Access Compliance Report

Public Rights-of-Way

(Curb Ramps)

Intersection ID: 9894	Main Street: TUCKASEEGEE_RD	Cross Street: WESTERWOOD_DR	Location:	N/A
ADA ID: AA989A0C175C	Ramp Type: BlendTrans1	Initial Pass/Fail: Fail	Overall Compliance: No	Severity Score: 10
Codes/Mitigation Info/Possible Solution		Field Measurements/Component Compliance

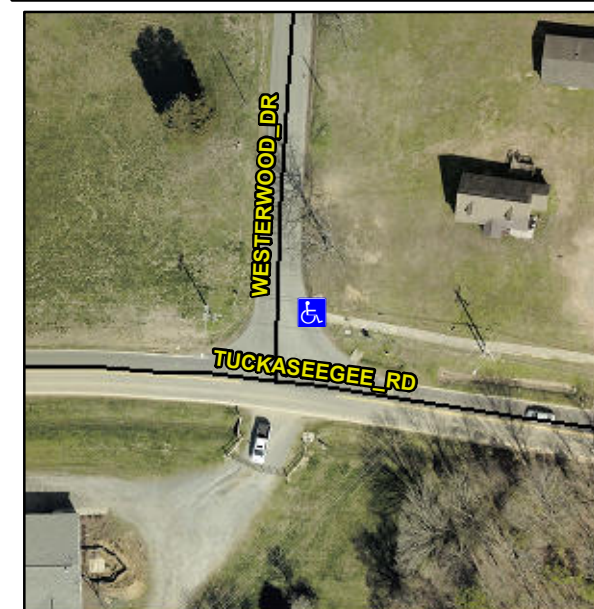
R304.5.1

Compliance	Description	Data	Compliance	Description	Data
N/A	Ramp Length (in)	29.0	Yes	BlendTrans Slope (%)	2.3
No	Ramp Width (in)	47.5	Yes	BlendTrans XSlope (%)	3.6
N/A	Flare Type LT	N/A	N/A	Flare Type RT	N/A
N/A	Flare Slope LT (%)	N/A	N/A	Flare Slope RT (%)	N/A
N/A	Flare Traversable LT?	N/A	N/A	Flare Traversable RT?	N/A
N/A	Landing Length (in)	N/A	N/A	DWS Provided?	N/A
N/A	Landing Width (in)	N/A	N/A	DWS Contrast?	N/A
N/A	Landing Slope (%)	N/A	N/A	DWS Length (in)	N/A
N/A	Landing X Slope (%)	N/A	N/A	DWS Full Width?	N/A
N/A	Landing Curb? (Y/N)	N/A	N/A	DWS Offset (in)	N/A
N/A	Shared Landing?	N/A			
N/A	Gutter Ponding?	N/A	N/A	Gutter Slope (%)	N/A
N/A	Gutter Lip Ht (in)	0.5	N/A	Gutter X Slope (%)	N/A
N/A	Painted X Walk1?	No	N/A	Painted X Walk2?	N/A
	X Walk 1 Direction	To W		X Walk 2 Direction	N/A
	X Walk 1 Width (in)	N/A		X Walk 2 Width (in)	N/A
	X Walk 1 Slope (%)	4.0		X Walk 2 Slope (%)	N/A
	X Walk 1 X Slope (%)	3.6		X Walk 2 X Slope (%)	N/A

Remove & Replace Curb Ramp With Two New Directional Ramps or Equivalent.
